A meeting of the **WAVERLEY LOCAL PLANNING PANEL** will be held on level 3, Waverley Council Chambers, Cnr Bondi Road and Paul Street, Bondi Junction at:

AGENDA

WLPP-1811.1 **PAGE 4** **20-24 Hall Street, Bondi Beach – Partial demolition of heritage listed building (Australia Post Office) and construction of a four storey mixed use development containing 2 basement levels of car parking, ground level retail with 10 residential units above. (DA-475/2017)**

Application number	DA-475/2017
Site address	20-24 Hall Street, BONDI BEACH
Proposal	Partial demolition of heritage listed building (Australia Post Office) and construction of a four storey mixed use development containing 2 basement levels of car parking, ground level retail with 10 residential units above.
Date of lodgement	7 November 2017 Amended plans and documentation: 24 April 2018, 5 May 2018 and 11 July 2018 Amended plans to WLPP deferral: 5 September 2018 and 19 October 2018
Owner	Australian Postal Corporation (at lodgement) Post Office Bondi Pty Ltd (following lodgement)
Applicant	Taylor Developments Group Pty Ltd c/o Urbis
Submissions	Original application: 35 unique submissions and approximately 1,323 pro-forma submis

1 ELEVATION SOUTH EAST JACQUES AVENUE

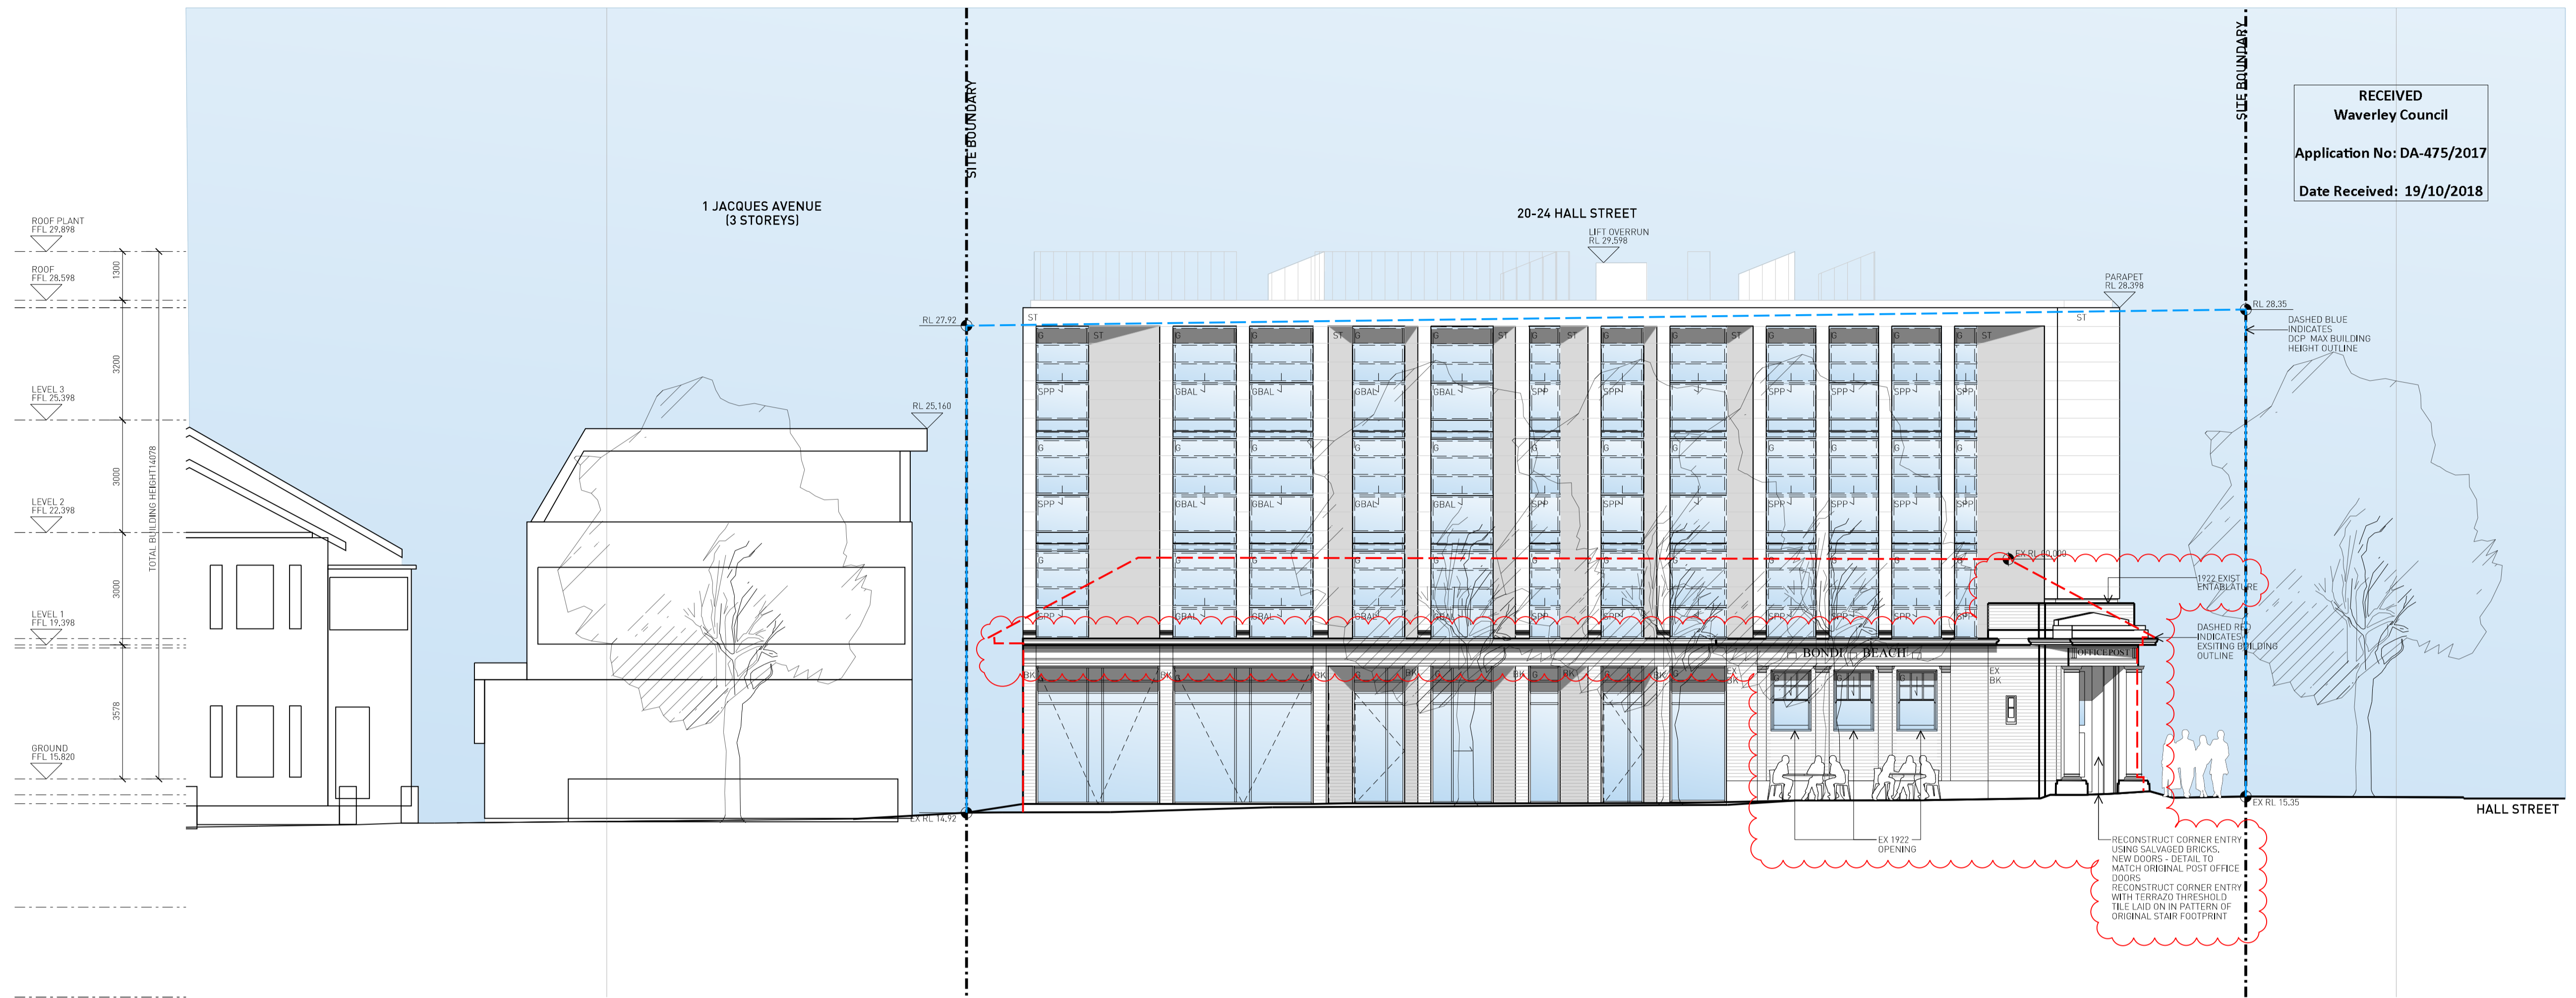
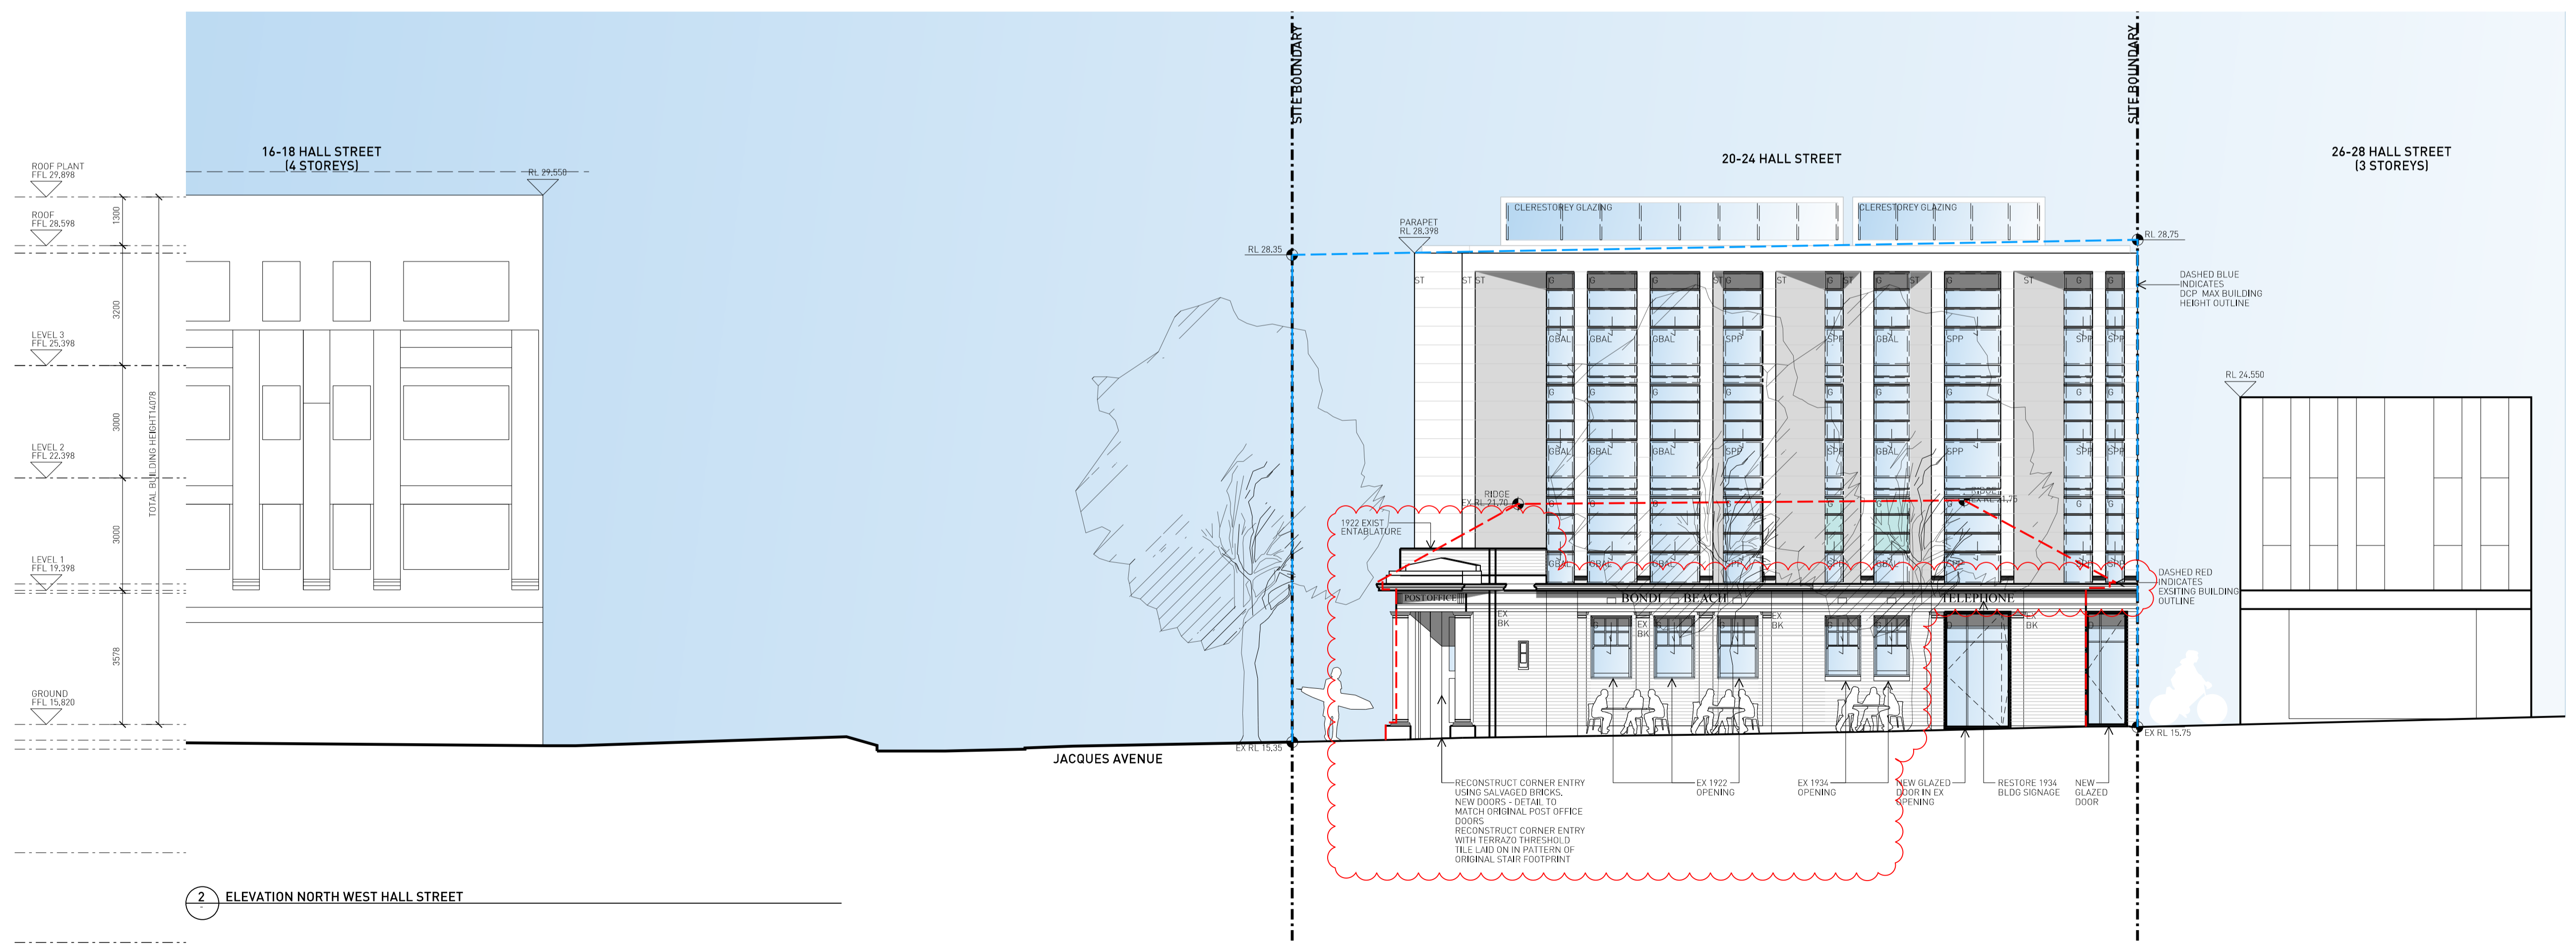
Deferral matter	Applicant's response	Planning comment
<p><i>The Panel is not satisfied with the proposed heritage outcomes for the site and in particular the architectural treatment, including not:</i></p> <ul style="list-style-type: none"> - Retaining the entirety of the street façade - Retaining the entry entablature complete - Reconstructing the corner front door - Retaining the majority of the windows openings and timber windows - Reconstructing the corner front door 	<p>In response to the Panel's concerns with the architectural treatment, a range of amendments to the plans are proposed, including:</p> <ul style="list-style-type: none"> - <u>Street façade</u> the existing original (1922) and early (1934 extension) have been retained and conserved. The street facades which were later and are heavily modified (post 1949) additions are proposed to be demolished and replaced with a high-quality addition that is consistent with the architectural language of the heritage fabric retained. - <u>Reinstatement of the western Hall Street entrance</u> the treatment of the 1934 entry off Hall Street has been reinstated with new doors and associated glazing set back from the entry within an open lobby. With interpretive screen images of the historic images. - <u>Western elevation</u> the western elevation will have a brick return for the ground floor along the laneway - <u>Entry entablature</u> the entry entablatures are now retained - <u>Corner front door</u> the corner front door is now retained, and the internal porch has been reinterpreted as requested by the Panel. - <u>Window openings and timber windows</u> all window openings and timber windows are now retained in their original form. 	<p>The amended proposal retains more of the heritage significant features that the original proposal. This includes retention of the window openings and timber windows. The amendments also reinstates significant entrances including the side entrance on Hall Street with interpretive telephone booth features, and the corner front entry entablature and corner front door.</p>

<p><i>Revised designs should be provided which include a new cornice/parapet element as a transition between retained facades and new facades</i></p>	<p>The amended DA drawings provide revised designs which include changes to the cornice / parapet to provide a better transition between the retained facades and new facades.</p>	<p>The additional drawings are considered to show adequate detail regarding the retention of the cornice parapet.</p>
